# Technical Bulletin

Subject: **CD Changer, Grounding**

Number: **95-04**

Model(s): **All with Panasonic CD Changer**

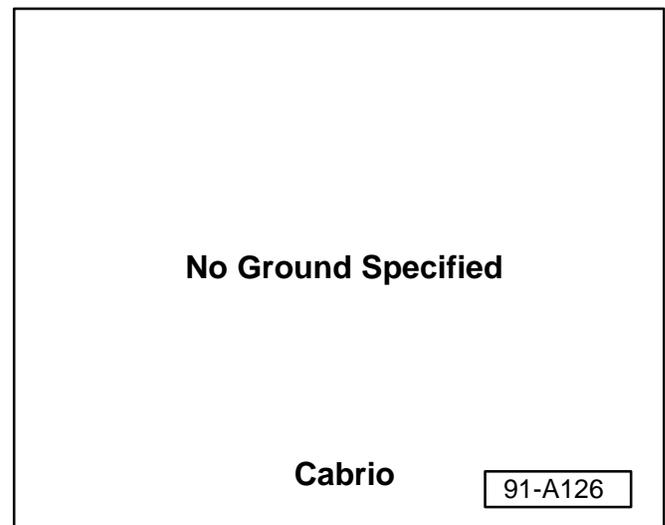
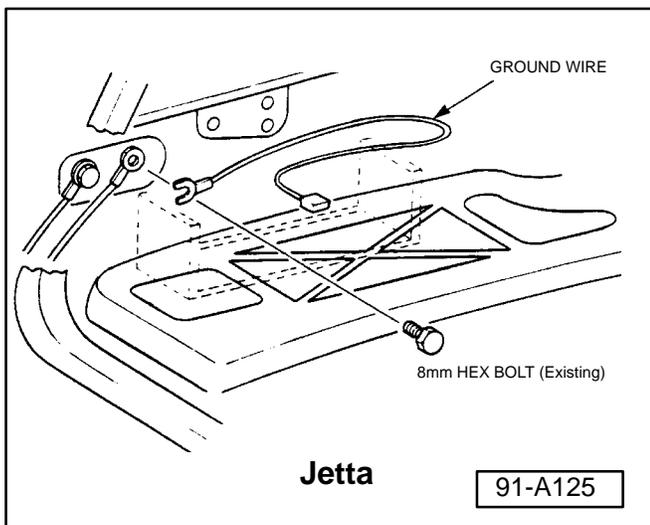
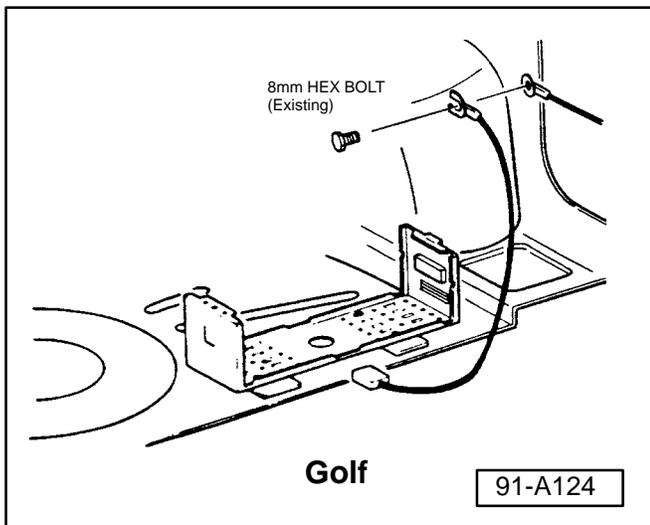
Noise while using the CD changer can be caused by the installation of an additional ground wire.

This ground wire can introduce noise into the system and is not necessary for the CD changer to function.

- Using the following illustrations as a guide, inspect for the additional ground wire in the locations shown.
- Remove additional ground wire.

**When installing NEW CD changers DO NOT install this additional ground wire.**
